SERVICE BULLETIN

Bulletin No. MC75-1
Date February 14, 1975
Page 1 of 1

SUBJECT: **MODIFIED R.H. CRANKSHAFT OIL SEAL**
Affected Models: **GT750**
Effective Engine No.: **GT750-54214**
Reference:

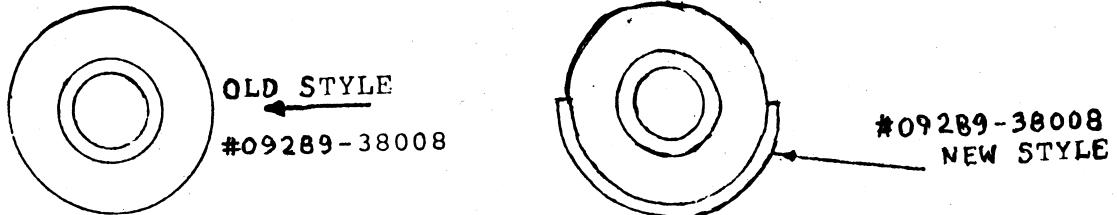
The excessive smoking was attributed to the right inboard crankshaft oil seal becoming displaced, allowing transmission oil to pass into the right cylinders crankcase.

To provide a more positive method of positioning the right inboard oil seal, a metal flange has been added to the seal.

The new style seal's flange eliminates the old style seal's positioning "C"-ring (Part No. 09390-78003). The flange of the oil seal should be placed in the "C"-ring's crankcase groove when positioning the crankshaft assembly in the lower crankcase half. Only the new style oil seal (09289-38008) will be supplied from the parts department.
